ATI-AZ-003

MODEL: iR2200/ 2800 / 3300**SUBJECT:** Inner 2-Way Tray-A1**Detail:****IMPORTANT POINT TO BE FOLLOWED IN INSTALLING INNER 2WAY TRAY-A1**

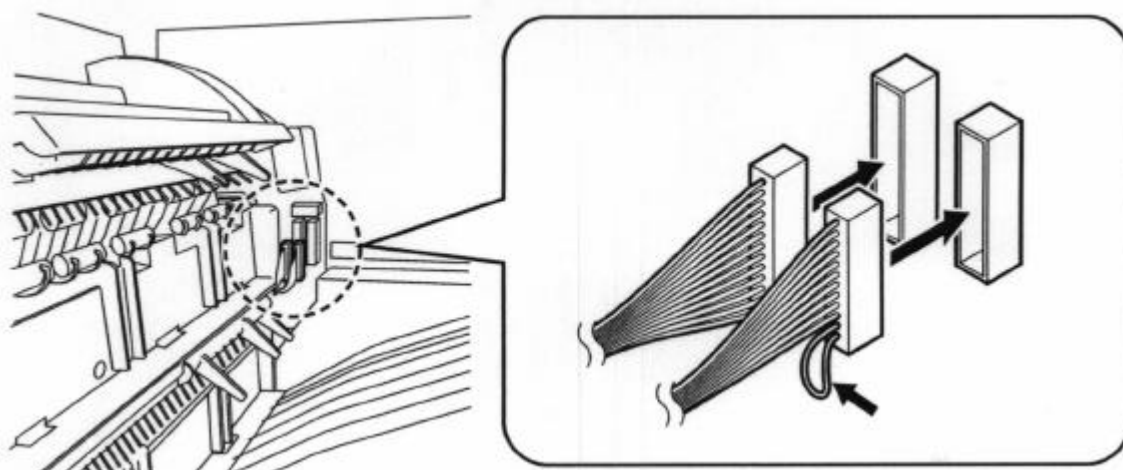
When an inner 2way Tray-A1 is installed, there is a possibility of two connectors being inserted alternatively, and this will cause a machine malfunction. At worst, it will result in breakage of sensors of DC Controllers.

Please be sure that those two connectors are inserted into the appropriated jack.
(13-pin connector should be left and 12-pin with a short line be right).
